HISTORIC AND DESIGN REVIEW COMMISSION

HDRC CASE NO: 2017-655

ADDRESS: 1910 E HOUSTON,

TYPE OF WORK: Site plan review for nine, single family residential structures

LOT 44 - ELEVATION

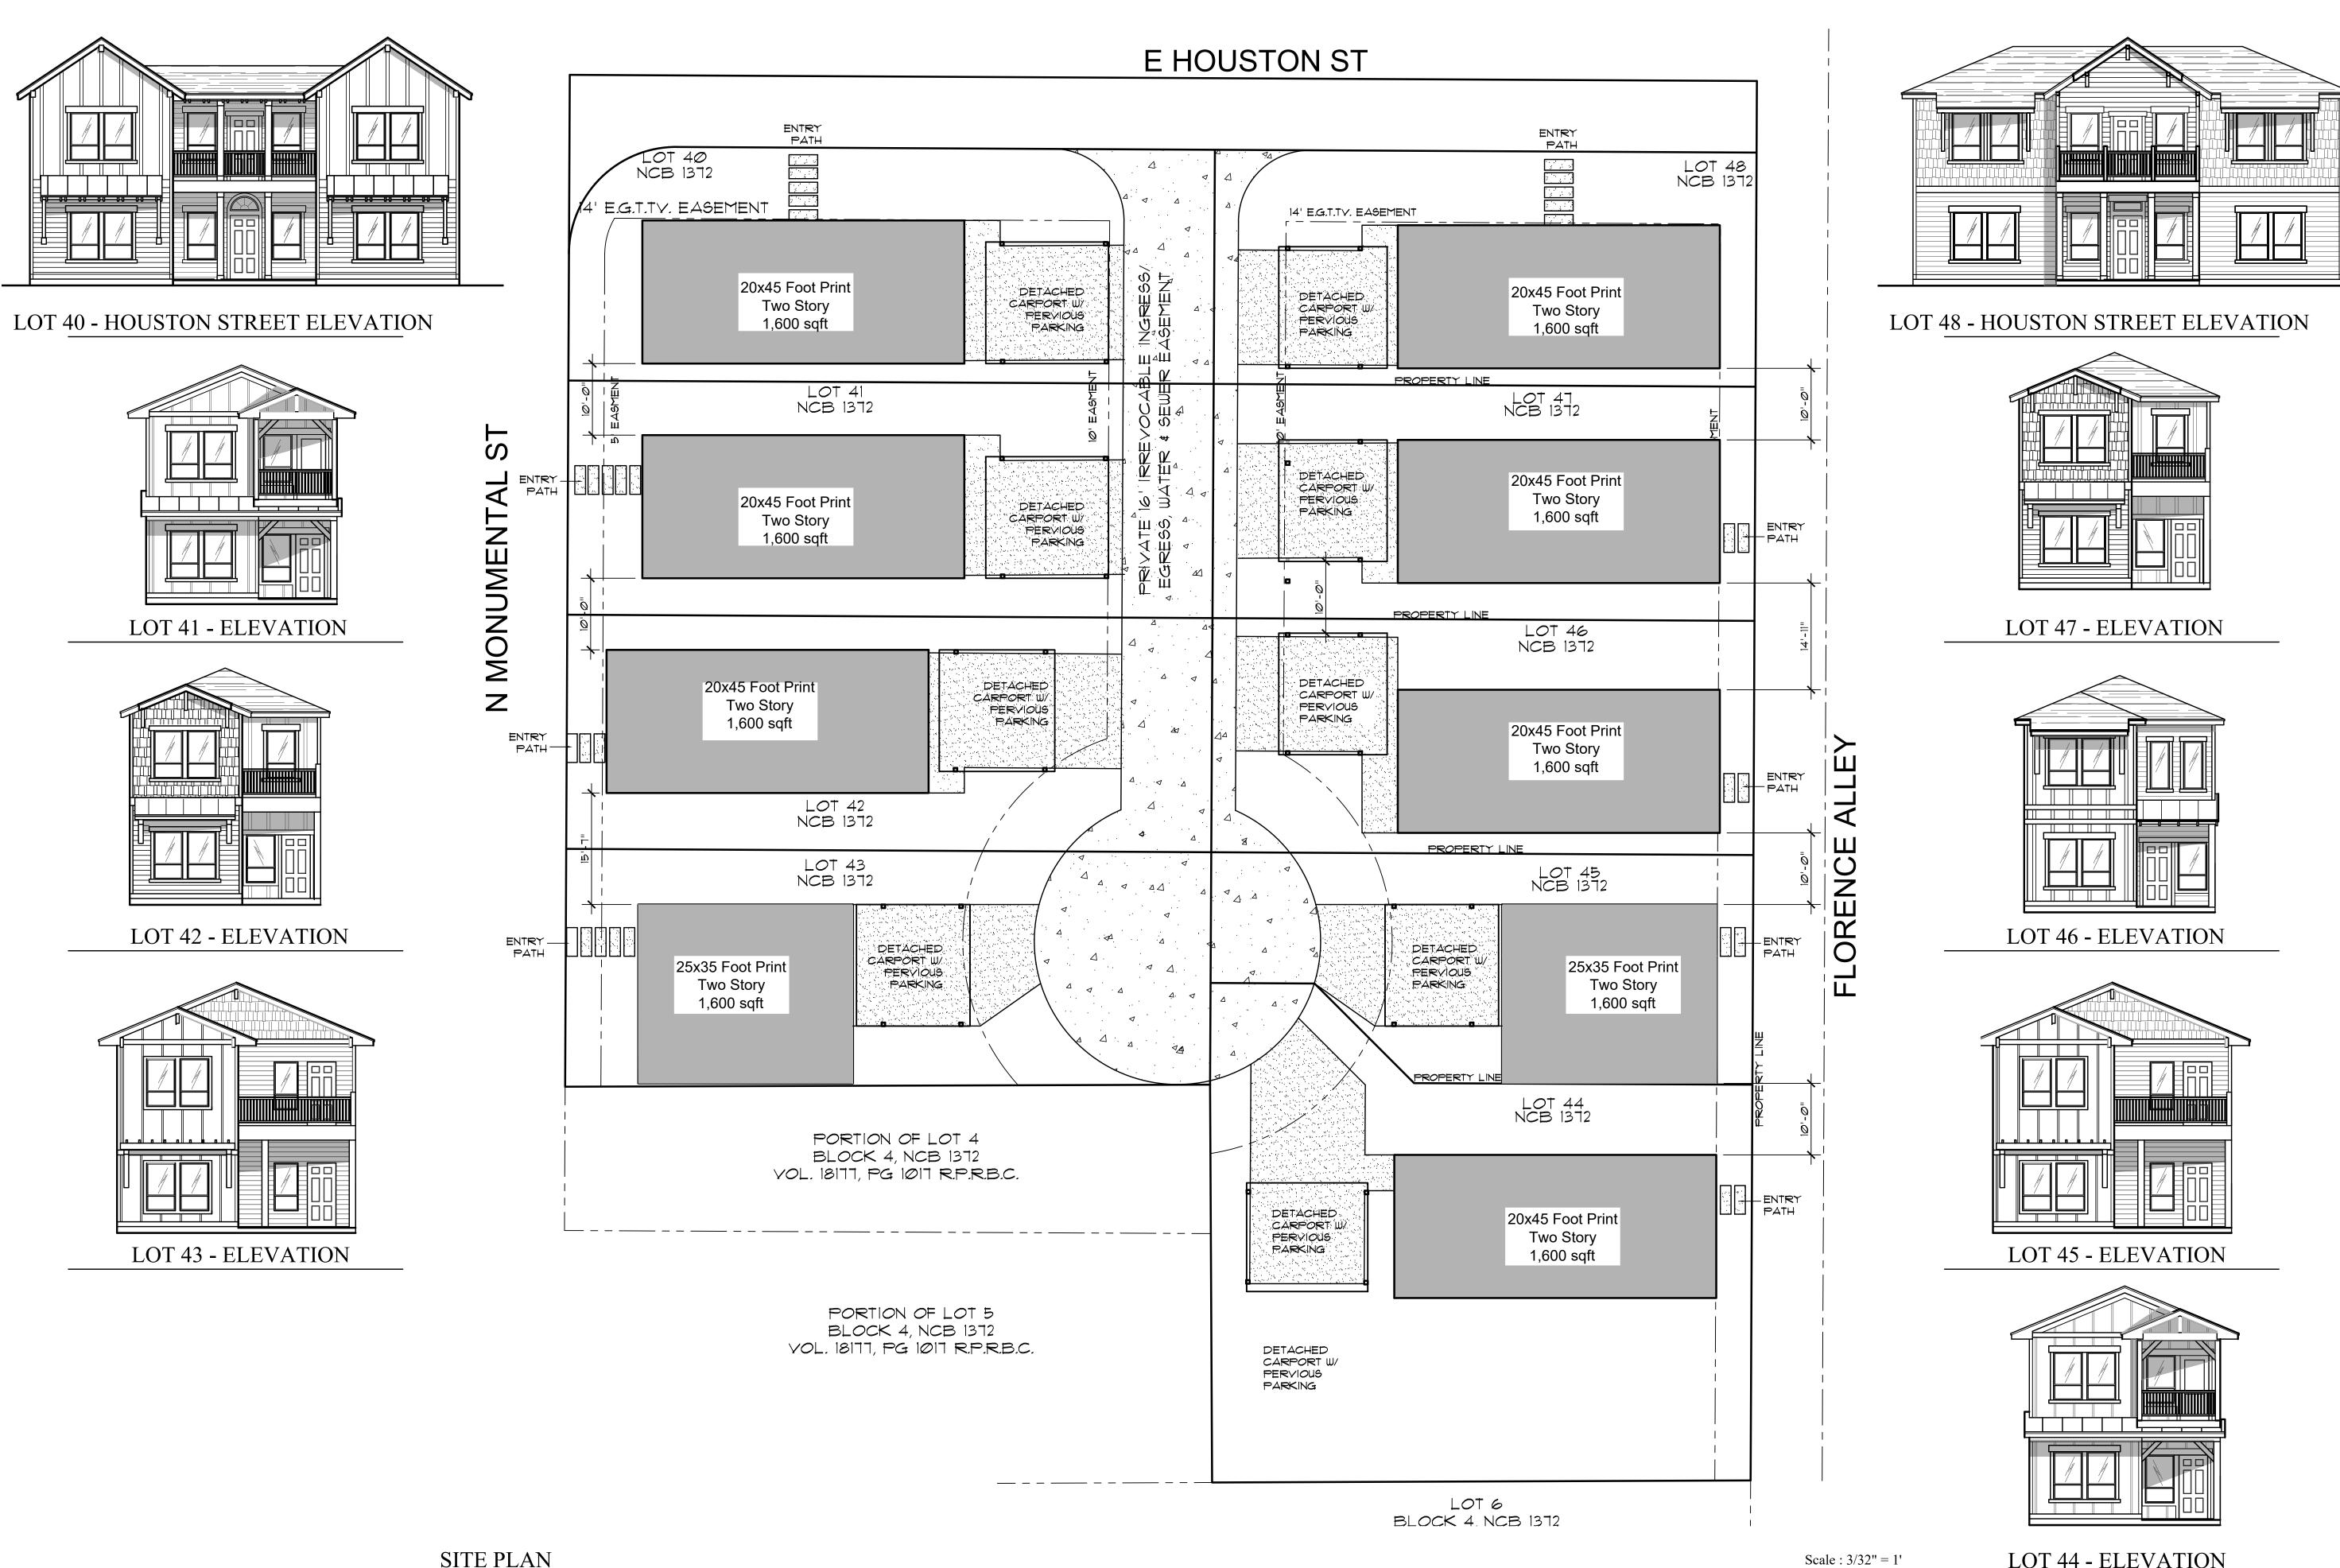
- i. ROOF FORM The applicant has proposed roof forms that include gabled and hipped roofs, both of which are found throughout the Dignowity Hill Historic District. Staff finds that the proposed soffit boxes should be eliminated.

- j. WINDOW & DOOR OPENINGS At this time, the applicant has provided general information regarding window and door openings, including proportions and locations. Staff finds the general number and location of openings to be appropriate; however, staff finds that proportions should more closely relate to those of historic structures found in the district.

- 1. ARCHITECTURAL DETAILS New building should be designed to reflect their time while representing the historic context of the district. Additionally, architectural details should be complementary in nature and should not detract from nearby historic structures. Generally, staff finds the proposed architectural massing and details to be appropriate. Design specifics including column design are to be submitted to staff when submitting for final approval.

- iii. That the proposed soffit boxes should be eliminated.
- iv. That all mechanical equipment be screened from view at the public right of way.
- v. That all proposed window proportions and placement relate to the historic pattern found throughout the district. This is to include sill and head heights as well as mullion widths. Window proportions should directly relate to those found on neighboring historic structures.

- vi. Regarding window materials, white manufacturer's color is not allowed, and color selection must be presented to staff. There should be a minimum of two inches in depth between the front face of the window trim and the front face of the top window sash. This must be accomplished by recessing the window sufficiently within the opening or with the installation of additional window trim to add thickness. Window trim must feature traditional dimensions and an architecturally appropriate sill detail. Window track components must be painted to match the window trim or concealed by a wood window screen set within the opening. Details on each should be submitted to staff for review.
